E/ECE/324
E/ECE/TRANS/505 } Rev.1/Add.90/Amend.3

Addendum 90: Regulation No. 91

Amendment 3

UNIFORM PROVISIONS CONCERNING THE APPROVAL OF SIDE-MARKER LAMPS FOR MOTOR VEHICLES AND THEIR TRAILERS

Annex 3, Example 1 (a) ,amend to read:

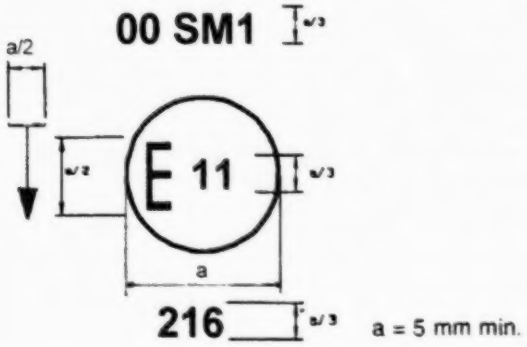
Annex 3, add a new sentence at the end of the caption below the figure, to read:

".... number 216. The vertical arrow starting from a horizontal segment and directed downwards indicates a permissible mounting height of equal to or less than 750 mm from the ground for this device.
